NAVIGATION - STALL WARNING HORN REPLACEMENT FOR CESSNA MODELS 180, 185, 188

The original stall warning horn is no longer available. If the stall warning horn needs to be replaced a new stall warning horn and bracket are available.

SEB-34-33
Page 1 of 11

Figure 1. Cessna Model 180 and 185 Before Modification (Sheet 1)

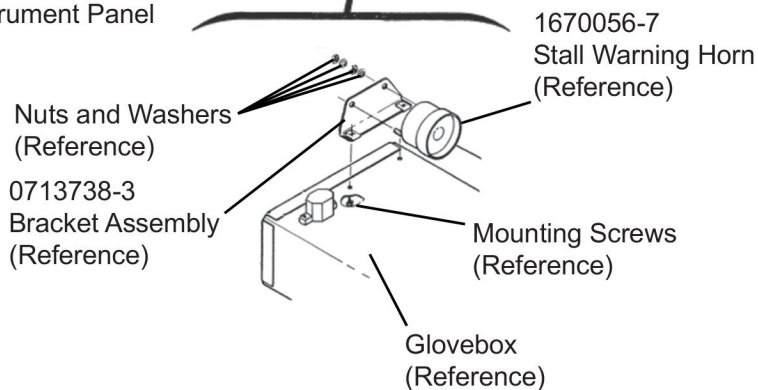
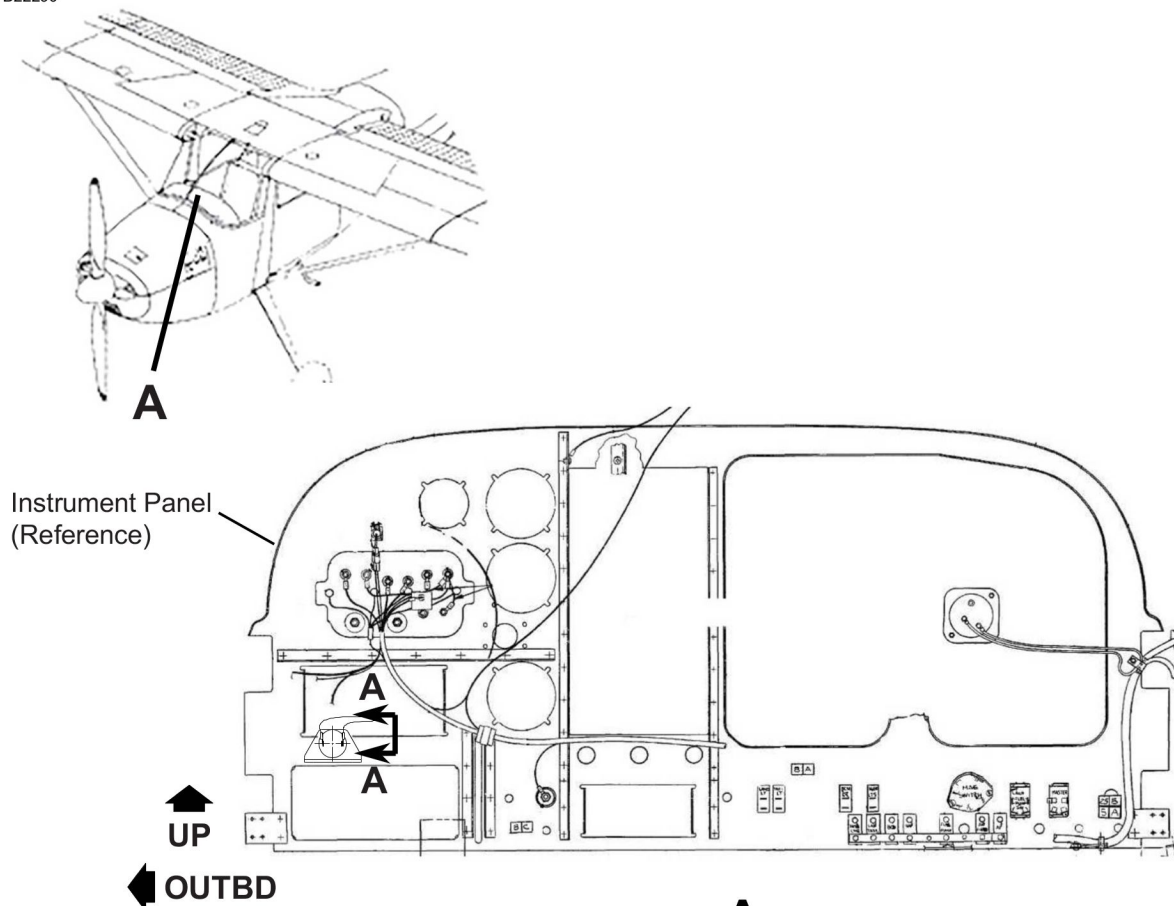
3. (Refer to Figure 1, Sheet 1.) Remove the 1670056-7 Stall Warning Horn as follows:
- A. Remove the copilot seat.
B. Remove and keep the two mounting screws from the 1670056-7 Stall Warning Horn.
NOTE: The kept mounting screws will be used for installation.
C. Remove the nuts and washers from the studs of the 1670056-7 Stall Warning Horn.
D. Disconnect the electrical wiring from the 1670056-7 Stall Warning Horn.
E. Discard the 1670056-7 Stall Warning Horn and the 0713738-3 Bracket Assembly.

Figure 2. Cessna Model 180 and 185 After Modification (Sheet 1)

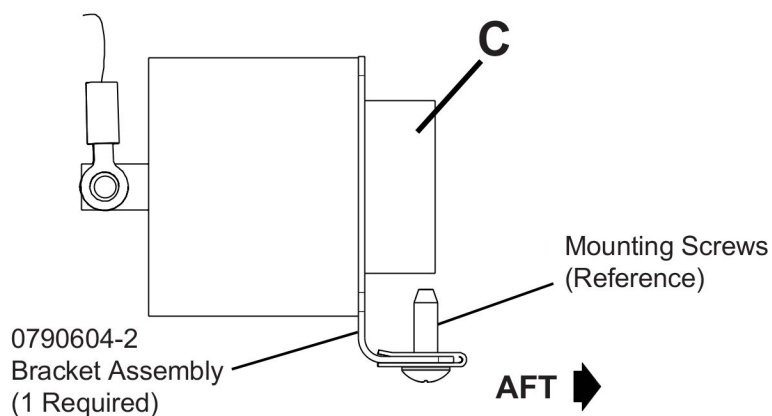
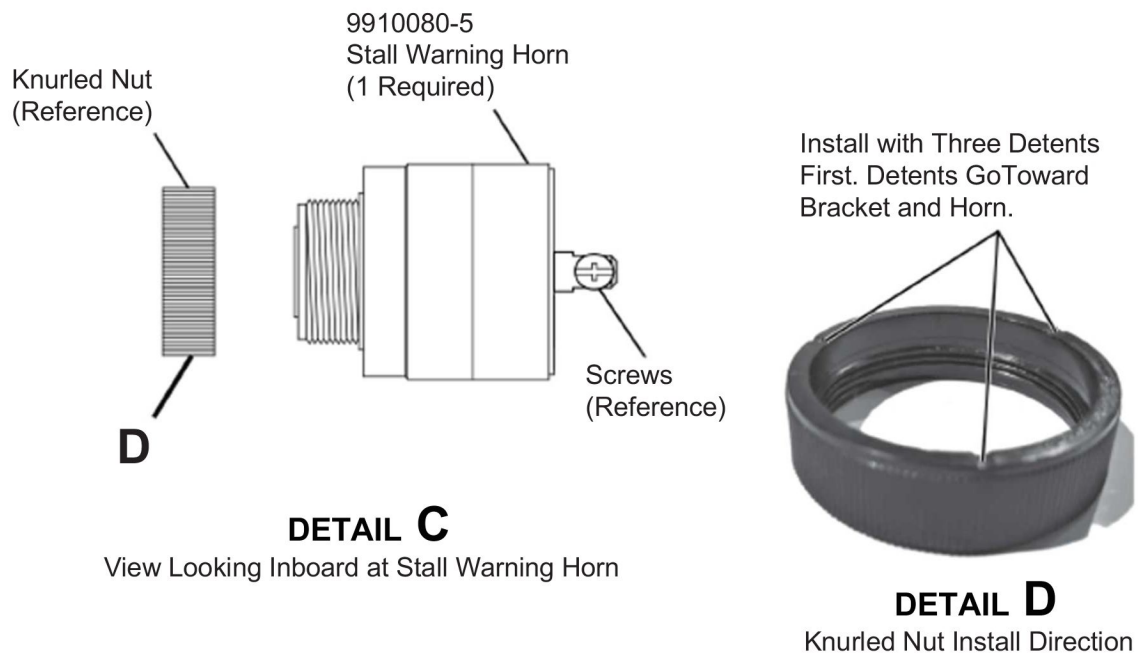
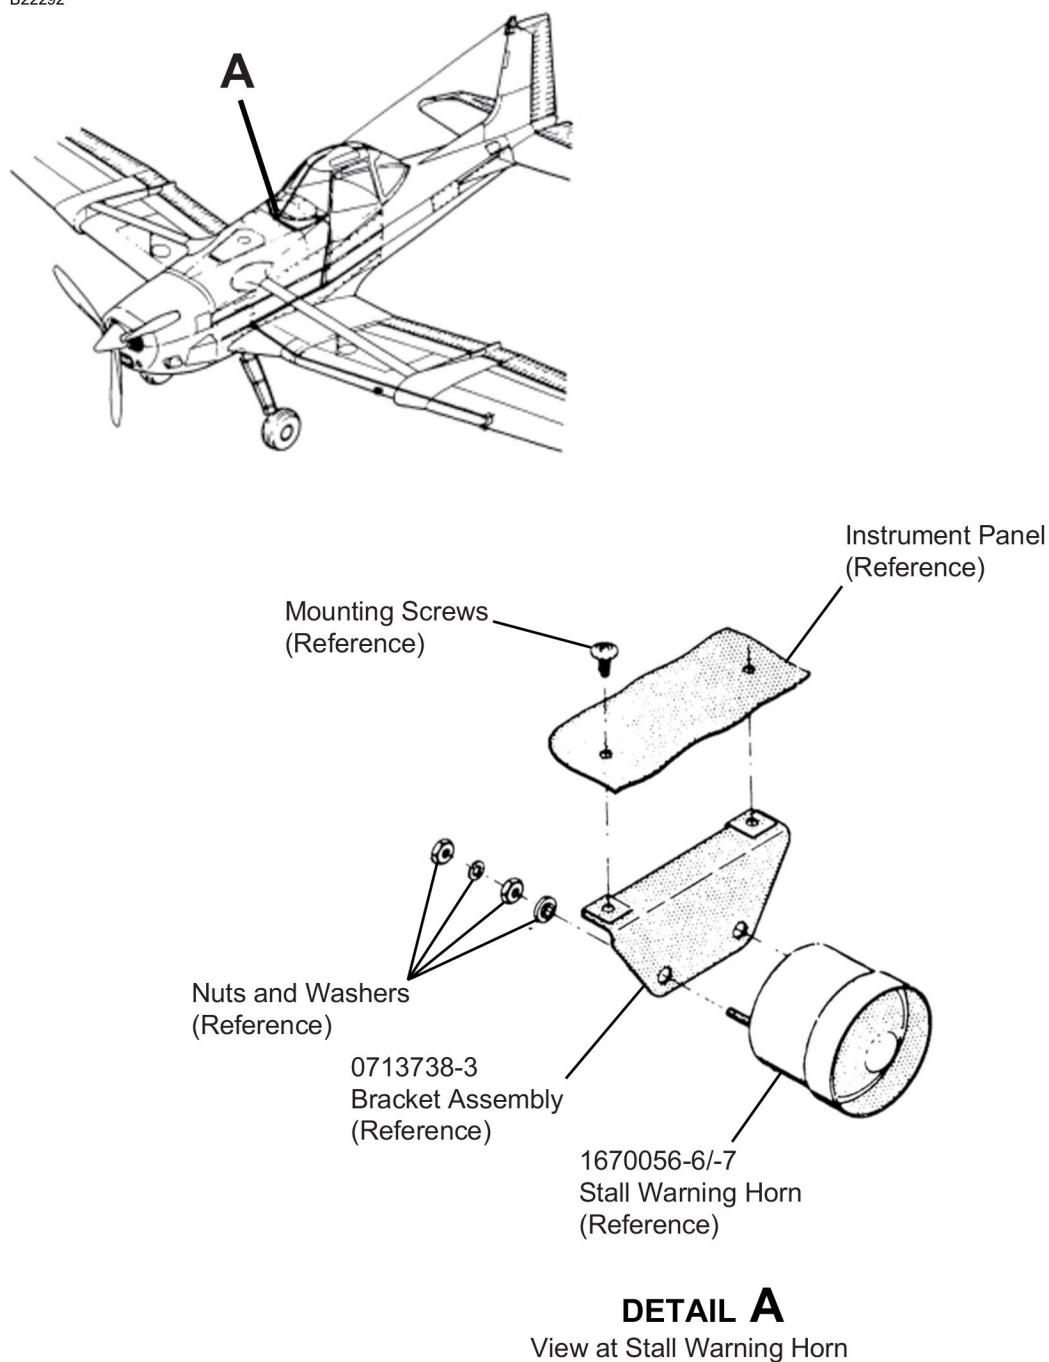
4. (Refer to Figure 2, Sheets 1 and 2.) Install the 9910080-5 Stall Warning Horn as follows:

- A. Install the 9910080-5 Stall Warning Horn into the 0790604-2 Bracket Assembly.
B. Install the knurled nut onto the 9910080-5 Landing Gear Warning Horn.

NOTE: The plastic knurled nut must be installed with the three indents toward the bracket and horn assembly. On the internal circumference, the smooth side without threads is installed first, towards the bracket and horn. This technique of installation will make sure the nut fully seats against the bracket and not bottom-out on the threads. If not installed correctly the knurled nut will bottom-out on the threads and the horn assembly will not be fully tightened in the bracket.

- C. Install the 0790604-2 Bracket Assembly onto the glovebox with the two kept mounting screws.
D. Install the electrical wiring onto the 9910080-5 Stall Warning Horn.

Figure 3. Cessna Model 188 Before Modification (Sheet 1)

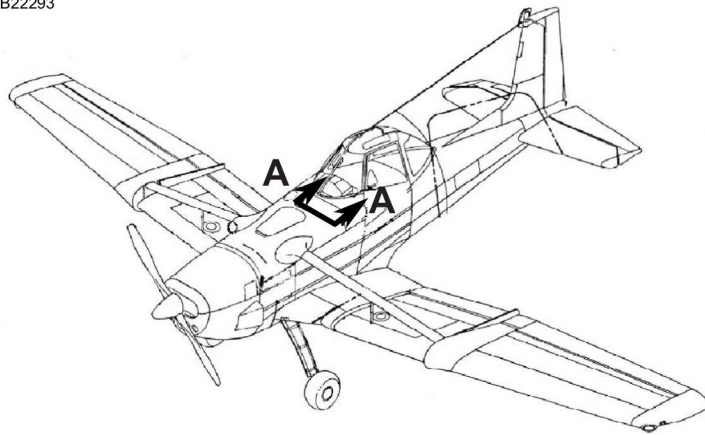
5. (Refer to Figure 3, Sheet 1.) Remove the 1670056-6/-7 Stall Warning Horn as follows:
 - A. Remove the pilot seat and any additional interior as necessary.

- B. Remove and keep the two mounting screws from the 1670056-6/-7 Stall Warning Horn.
NOTE: The kept mounting screws will be used for installation.
 - C. Remove the nuts and washers from the studs of the 1670056-6/-7 Stall Warning Horn.

- D. Disconnect the electrical wiring from the 1670056-6/-7 Stall Warning Horn.
 - E. Discard the 1670056-6/-7 Stall Warning Horn and the 0713738-3 Bracket Assembly.

Figure 4. Cessna Model 188 After Modification (Sheet 1)

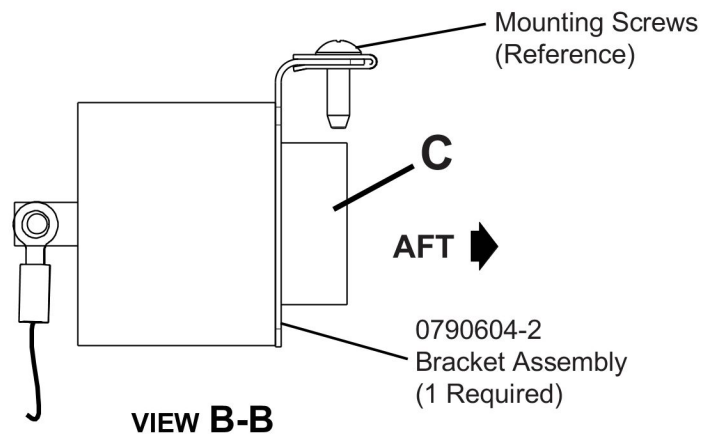
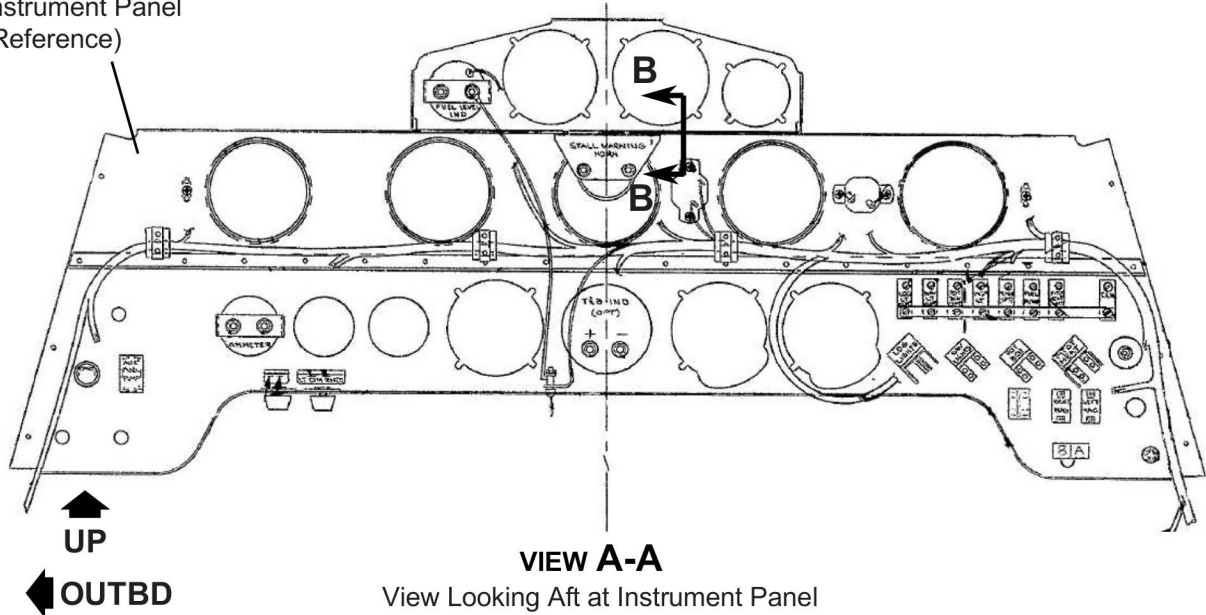
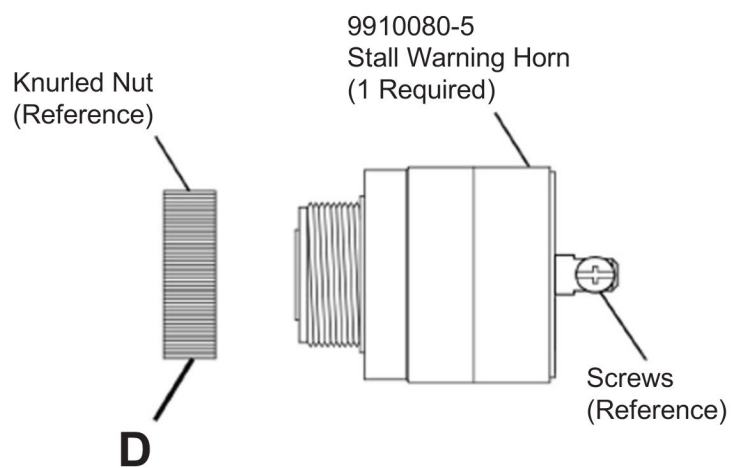
6. (Refer to Figure 4, Sheets 1 and 2.) Install the 9910080-5 Stall Warning Horn as follows:
 - A. Install the 9910080-5 Stall Warning Horn into the 0790604-2 Bracket Assembly.

- B. Install the knurled nut onto the 9910080-5 Landing Gear Warning Horn.
NOTE: The plastic knurled nut must be installed with the three indents toward the bracket and horn assembly. On the internal circumference, the smooth side without threads is installed first, towards the bracket and horn. This technique of installation will make sure the nut fully seats against the bracket and not bottom-out on the threads. If not installed correctly the knurled nut will bottom-out on the threads and the horn assembly will not be fully tightened in the bracket.

- C. Install the 0790604-2 Bracket Assembly onto the instrument panel with the two kept mounting screws.
 - D. Install the electrical wiring onto the 9910080-5 Stall Warning Horn.
NOTE: The screws that attach the wiring are supplied with the 9910080-5 Stall Warning Horn.
